# Lambertson Final Design Review Responses

## Dave Johnson

### November 20, 1995

Figure 1:

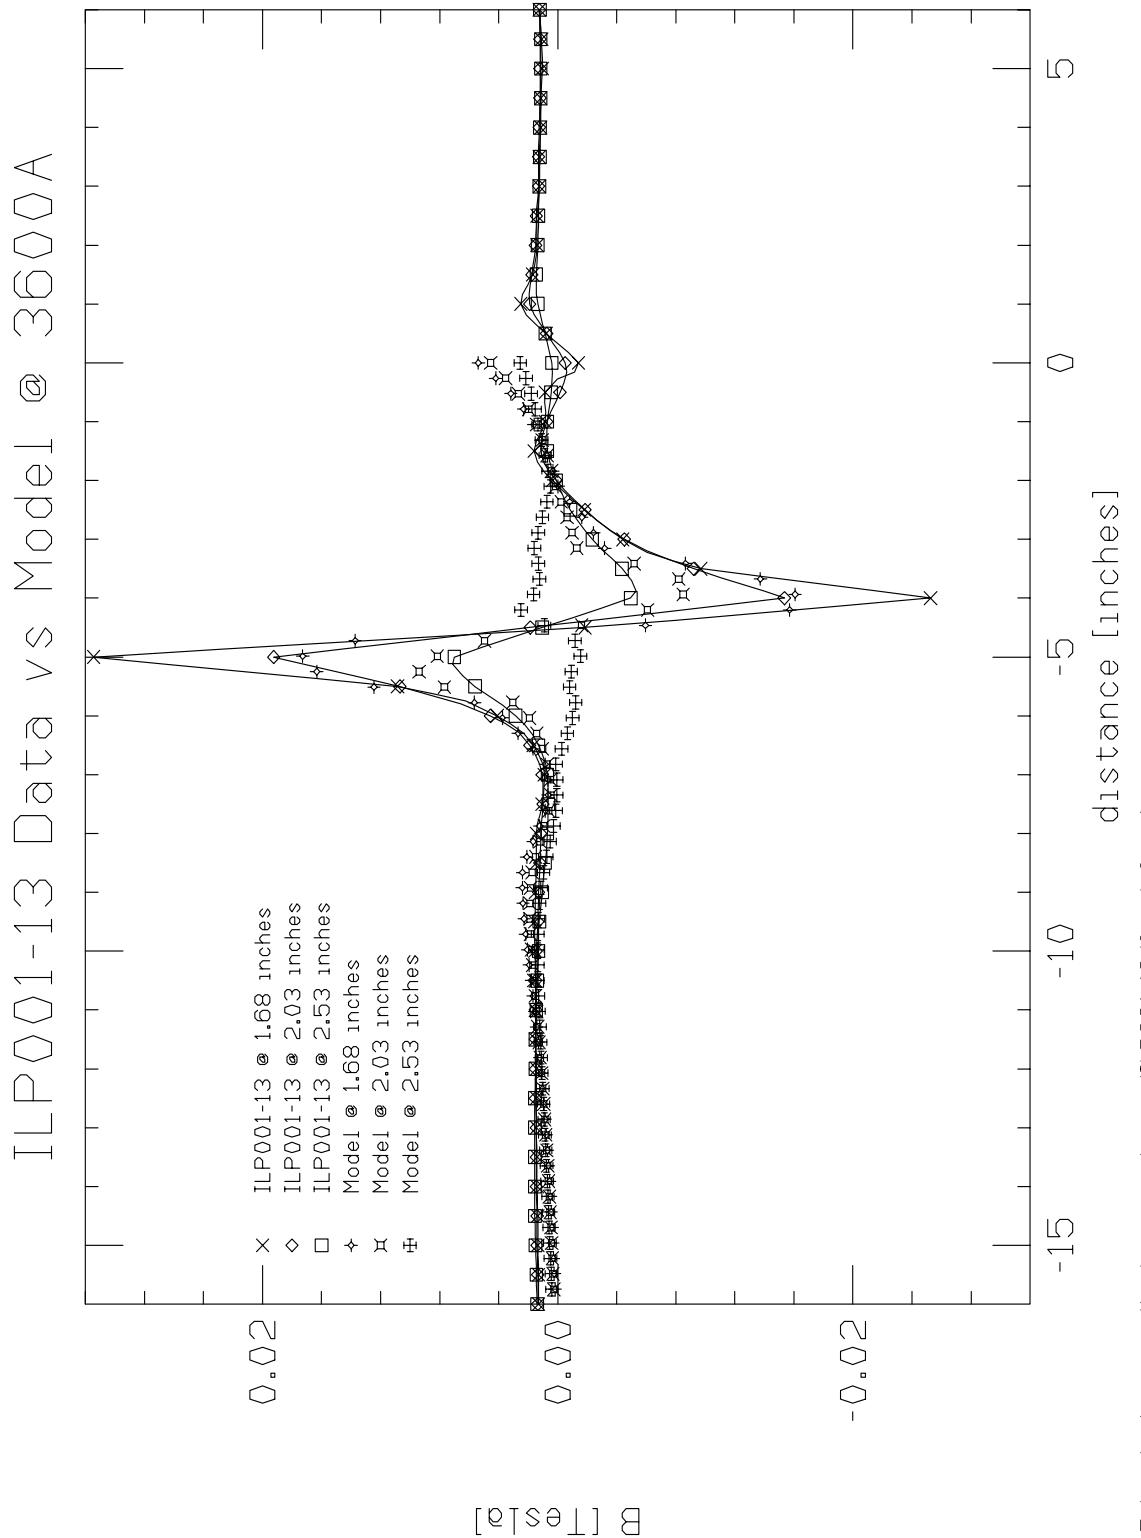
Recommendation: In the most recent metal model the saddle coil bent toward the zero field channel can be electrically disconnected and the other coil powered to twice the design cur-

rent. This configuration is close to the design configuration, and measurements of the fringe field should be able to confirm the computer prediction.

The committee’s recommendation of shorting half the saddle coil (the half saddle toward the field free region) and running the magnet at twice the current was followed. This resulted in the measurement of prototype configuration ILP001-13. The results of the magnetic tests are presented below and confirm the predictions of the computer model to the expected accuracy.

Figure 1 shows the measured field shape (solid line) for ILP001-13 and the computer model’s predictions of the field shape through the end plates. The end of the outer core and the start of the 4.3 inch inner core extension is at zero. The fields at positive distances measure the leakage fields into the field free region in the body of the magnet. The outside edge of the mirror plate is located at approximately 7.8 inches and is generally less than 15 Gauss. The discrepancy in the field shape between the prototype measurement and model is not unexpected due to small differences between the model and prototype, the small magnitude of the field, the number of nodes used in the calculation, and the requirement that the field go to zero at -15 inches in the model.

Figure 4:

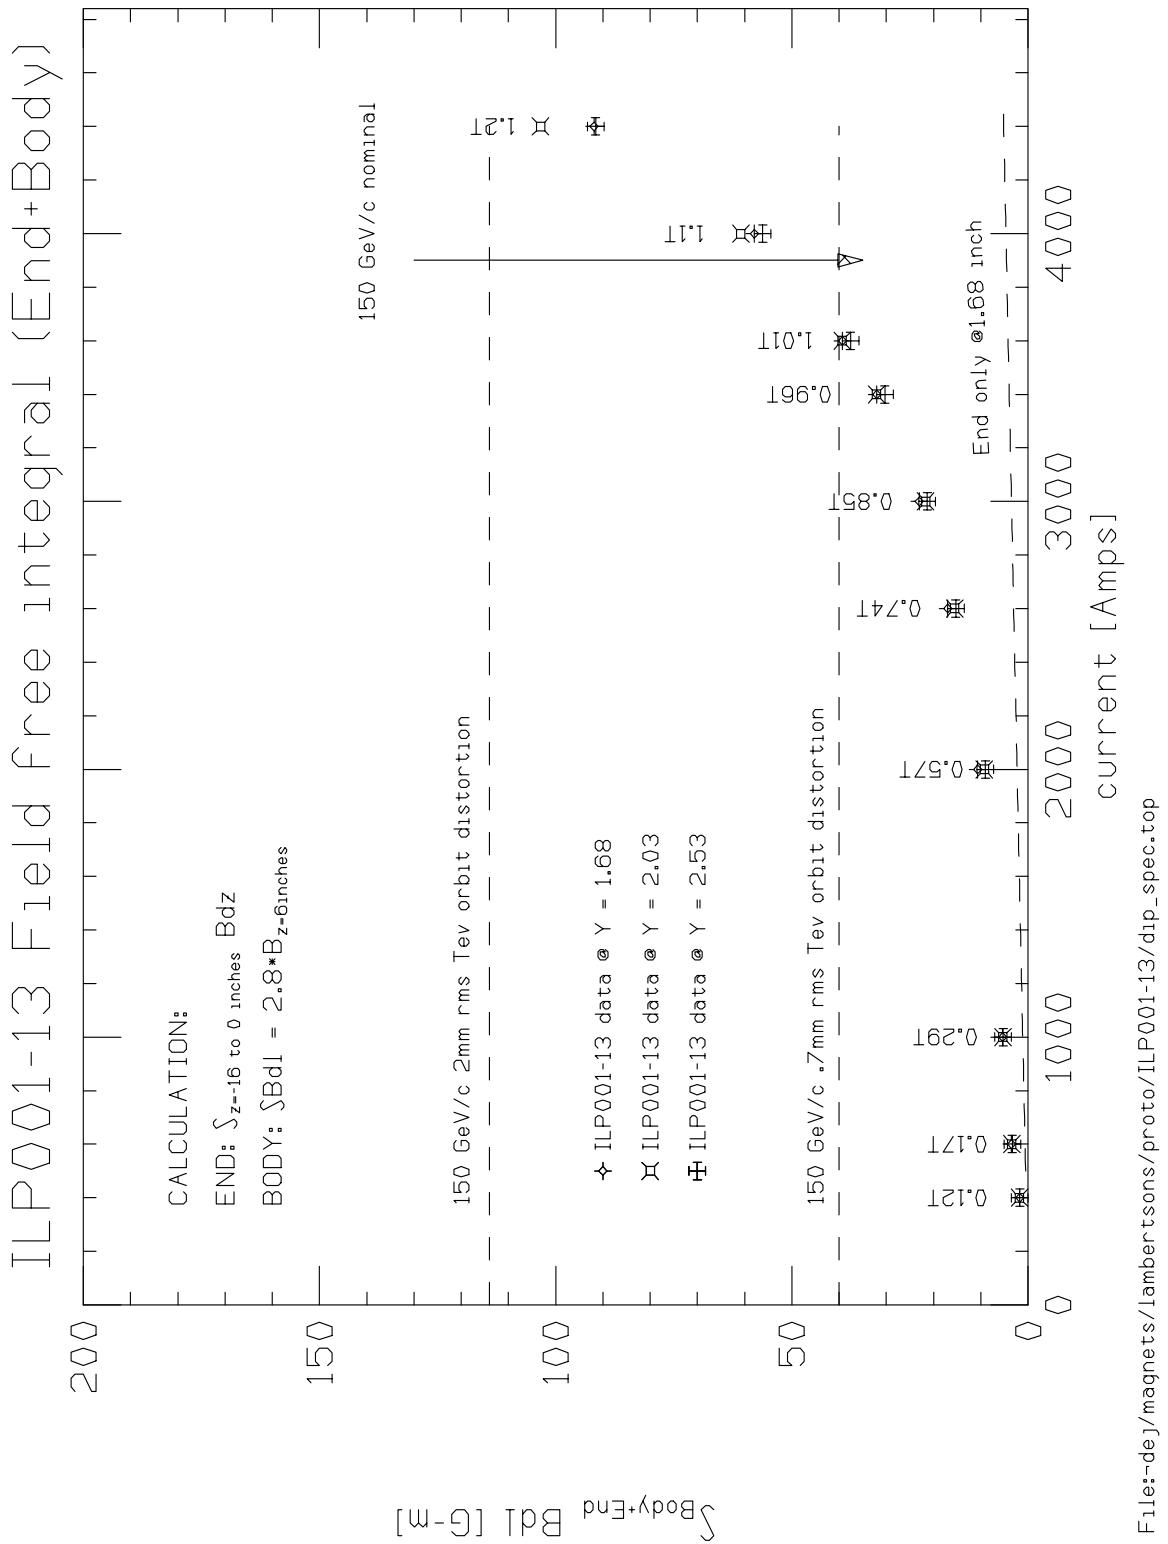
Recommendation: There should be readily available a concise statement of the accelerator physics requirements for the fringe field.

Figure 4 shows the dipole field integral (body+end) with the accelerator physics limits

discussed in recommendation 1 superimposed. Also included is the end dipole field integral for a single y (at 1.68 inches) position. The corresponding field in the bending region for each current is noted as well as the nominal design field of 1.072 T (at 3930 Amps). It should be noted that the main contribution to the integral is due to the body leakage field and that the contribution from the ends is a factor of 10 less than that of the body (which was the desired result). Additionally, it should be remembered that the integrated dipole field due to leakage in the body for the production Lambertsons is expected to be less than that of the prototype. This is due to a modified field free region geometry (smaller opening angle and larger septa radius) and better (higher permeability) steel around the field free region. Therefore, the data from the prototype (at the nominal 150 GeV/c excitation) is on the order of a factor of two better than the specification (0.0114 T-m) and the production magnet results are expected to be even better through the reduction of the leakage field in the body.
